**Attachment 7.2  
CONTAINMENT INSERVICE INSPECTION  
RECORD OF VT-3 / GENERAL VISUAL EXAMINATION**

IPEC Unit: 2 Interval Period: 1<sup>st</sup>/2<sup>nd</sup> Inspection Inspection Report No.: IP2-O5-IWL-001

Component No.: VCC - 06 Zone No: 003 Drawing No.: \_\_\_\_\_

IWL VISUAL CONTAINMENT INSPECTION  
 Indian Point Unit No. 2

ZONE No: 003

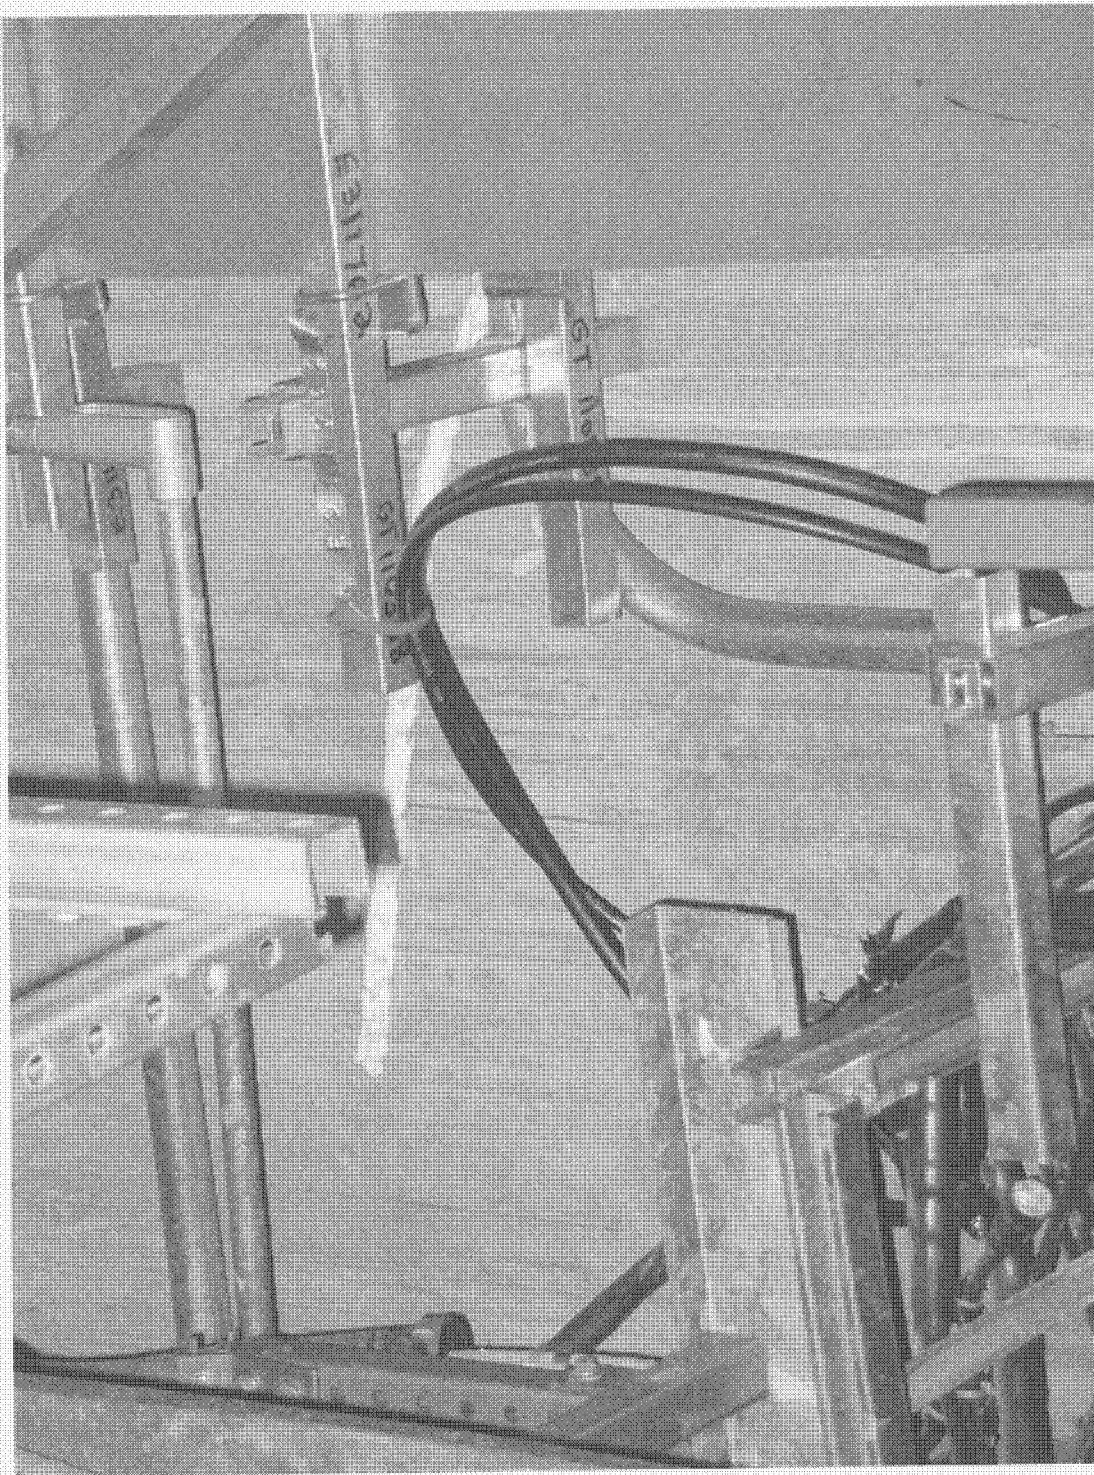
No.	Comment	Initials
1	Two pieces of embedded steel appearing to be cadweld splices are exposed at the surface of the concrete. Slight corrosion is evident but no streaking or staining of the concrete. This area has remained unchanged since previous inspection.	<i>WDF</i>
2	A small surface defect (approx. 2' dia) and several unfilled form tie holes were noted but are insignificant relative to containment structural integrity. These areas have remained unchanged since previous inspection. See photo U2-035208	<i>WDF</i>
3	Caulk, possibly covering a crack, diagonally approx. 10' long. See photos U2-035204, U2-035205, and U2-035206	<i>WDF</i>
4	This area was examined from the floor level at El. 46'. The examination distances were a maximum of 20 feet. While this distance exceeds the limits for direct visual examination, it was too short for use of the binoculars due to their minimum focal length. Lighting levels using the flashlight exceeded the 50 foot-candle requirement. Approximately 10% of this zone was not visible for inspection by direct line of sight due to various obstructions.	<i>WDF</i>

5	General minor bugholes.	<i>WDF</i>

ZONE No: 004

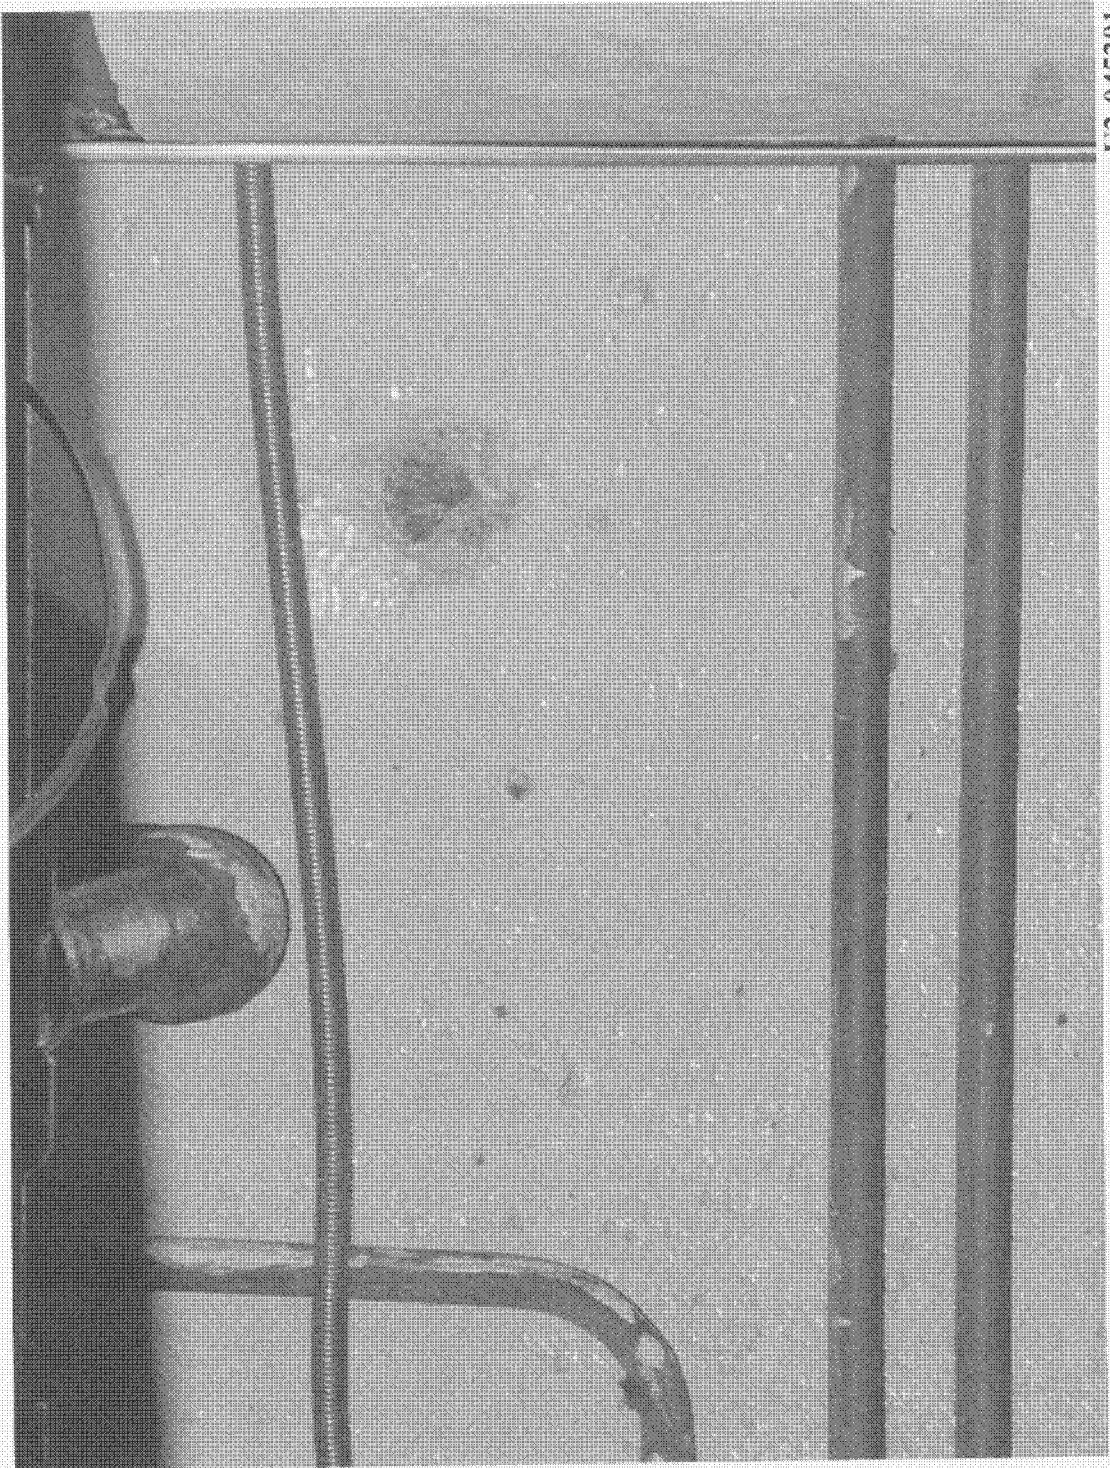
No.	Comment	Initials
1	This area was examined from the catwalk at approx. El. 51' due to radiological contamination of the floors in this area. The examination distances were a maximum of 30 feet. While this distance exceeds the limits for direct visual examination, it was too short for use of the binoculars due to their minimum focal length. Lighting levels using the flashlight exceeded the 50 foot-candle requirement. Approximately 50% of the concrete surface was not visible for inspection by direct line of sight due to obstructions.	<i>WJF</i>
2	Several form tie holes were found not filled. These have remained unchanged since previous inspection and are not significant relative to containment structural integrity.	<i>WJF</i>
3	New spalling (approximately 2" dia) has occurred. See photo U2-045201	<i>WJF</i>
4	Popouts (3"-9" in size) and joint spalling. Upon further review, it was found that this area has been coated with a sealant for fire barrier 1A/74A. Dowcorning 3-6548 silicone foam appears to have shrank and separated. See photos U2-045202 and U2-045203	<i>WJF</i>
